I-195 REDEVELOPMENT DISTRICT

RESOLUTION REGARDING APPROVAL OF WAIVERS FOR PARCELS 14 AND 15

RE: Parcels 14 & 15, Final Plan Approval Recommendation

Exhibit 1: Allowed Long-Term Bike Parking Design

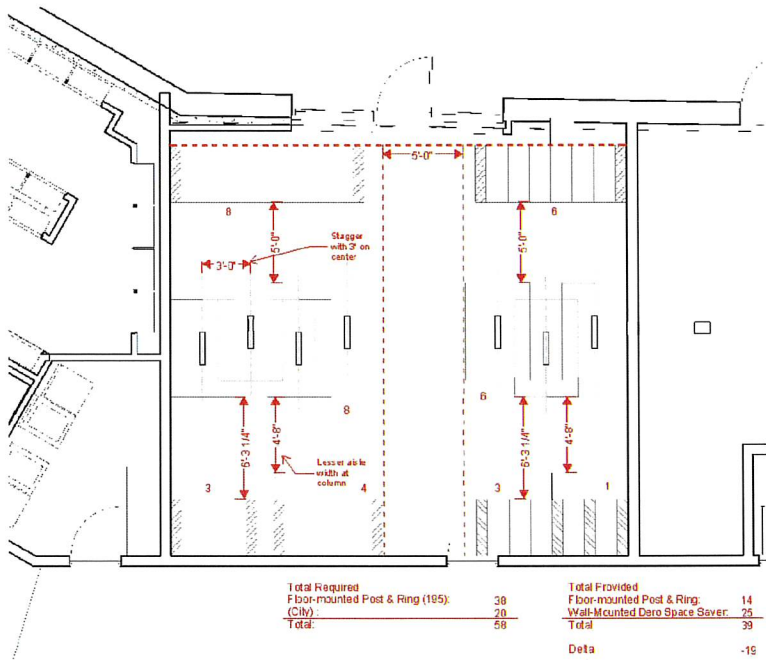
A reduction in the minimum number and an allowance for altered design for a limited number of the required Long-Term Bicycle Parking Spaces.

Specifically, allowing the design of the bike room attached to this memo as **Exhibit 1**, which uses a mix of floor-mounted post and ring racks and wall-mounted racks, for a total of 39 spaces. Because this is the first and most dimensionally constrained phase of a multi-phase development, we recommend that the deficit of 19 Long-Term Bicycle Parking Spaces associated with this development be provided as part of the later phases of the development and made available to residents of this building.

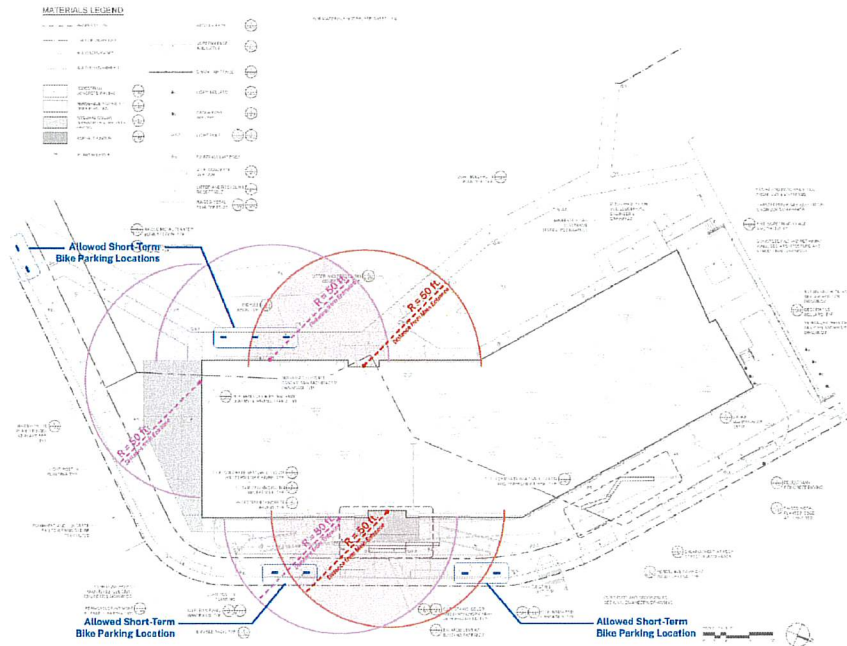
An allowance for the required Short-Term Bicycle Parking Spaces to be located more than 50ft from the primary entryways to the residential units and ground floor retail space, provided the spaces are located on the closest available level sidewalk or plaza space that avoids conflicts with crosswalks and accessibility features, street trees, above-ground utility features, and walkways from sidewalk grade to DFE-1. Specifically, allowing Short-Term Bike Parking spaces to be located in the places indicated by the diagram attached to this memo as **Exhibit 2**.

Exhibit 3: Allowed Exterior Loading Dock Design

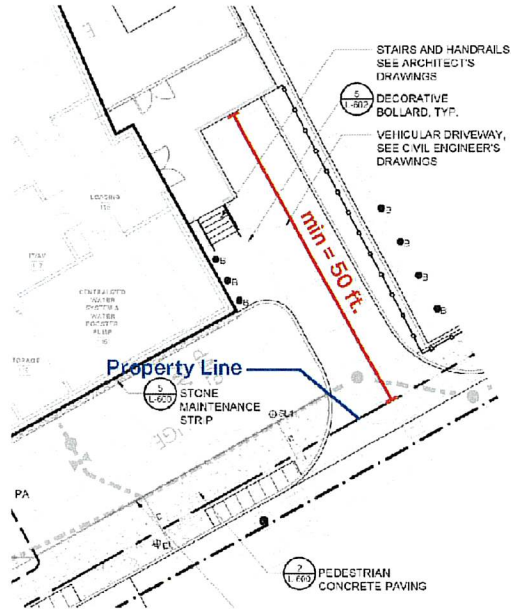
Allow an exterior loading dock along Peck St where there will be the least impact on public realm experience, provided they are set back from the property line by at least 50 feet as indicated in the attached **Exhibit 3** and all loading support spaces, including trash, are located on the interior of the building. Stairways and pedestrian access to the loading dock and associated interior spaces are permitted be closer to the property line.

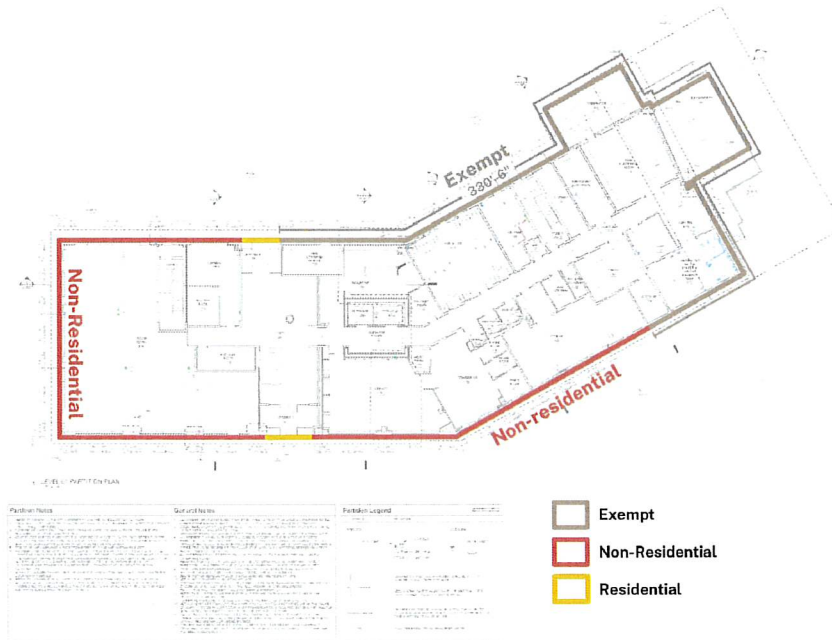
Allow the areas of the facade enclosing back of house spaces as indicated in

the attached **Exhibit 4**, measuring up to 330'-6" linear feet, to be opaque walls without transparency or exterior building entrances, provided they are screened effectively by plantings.
